Product Bulletin # TDS-251 Rev 2

Mudline Mount Inspection

Canrig Top Drives models C500 and C750 (formerly 1250AC and 1275AC)

Figure 3: Secondary retention on mudline mount

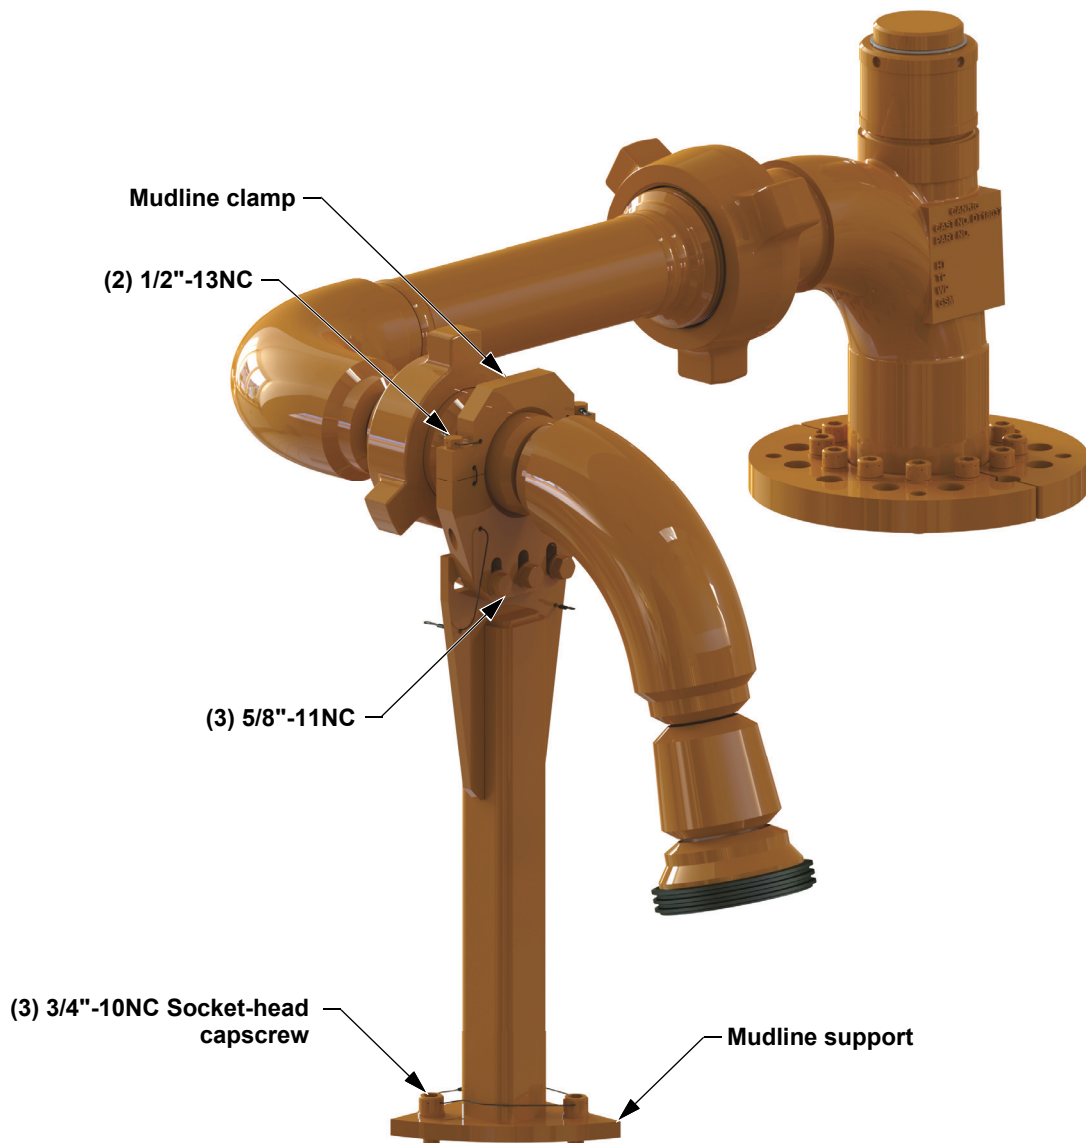
2. Visually inspect the mudline mount and clamp to ensure secondary retention and safety securement has been installed and secured as shown in Figure 3. Refer to bulletin "[Mudline Clamp Alert](#)" (TDS-155) for further guidance on mudline clamp installation.

Figure 4: Mudline safety securement (Pad-eye) detail

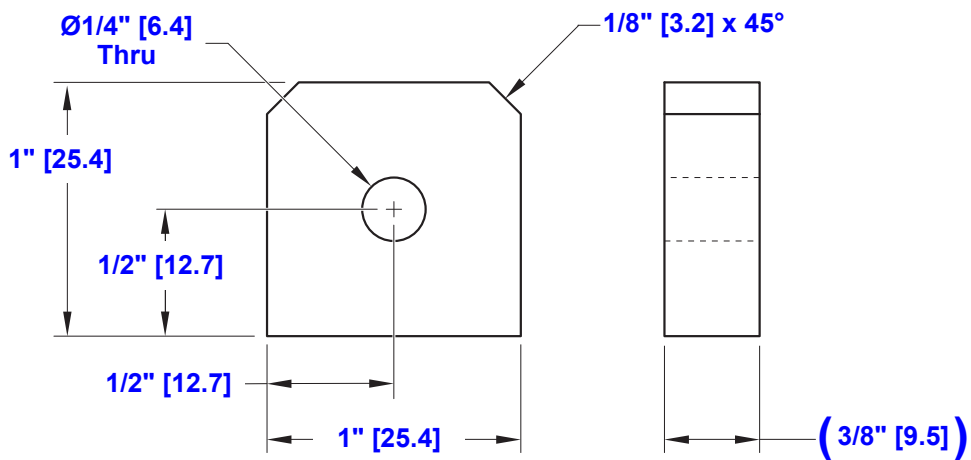
As an improvement, the mudline mount can be modified to include gussets and a safety securement pad-eye, as shown in Figure 4 and Figure 5. A provision to add safety securement in the event the mudline mount welded joint fails is shown in Figure 6 and Figure 7. **Material: ASTM A36 or equivalent** is required for the Pad-eye and gusset details.
